PRODUCT CHANGE NOTIFICATION

Product Identification: 0ZLJXXXXXXXX,0ZLKXXXXXXXX,0ZLMXXXXXXXX

PCN Number: PCN-F260009

Marking example:

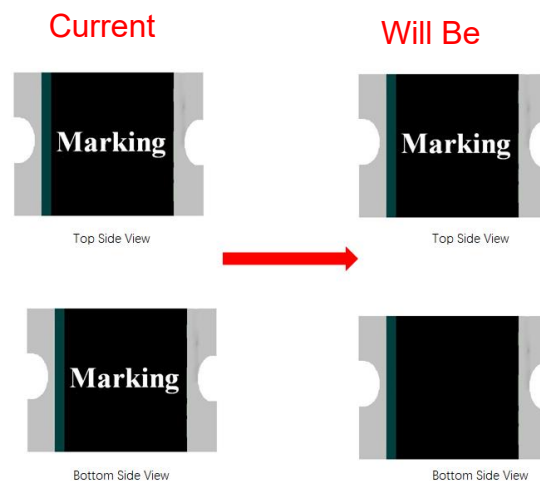
0ZLJ,0ZLK, 0ZLM Series change the product marking from "double-sided marking" to "single-sided marking". The no-marking side is intended to improve soldering performance.
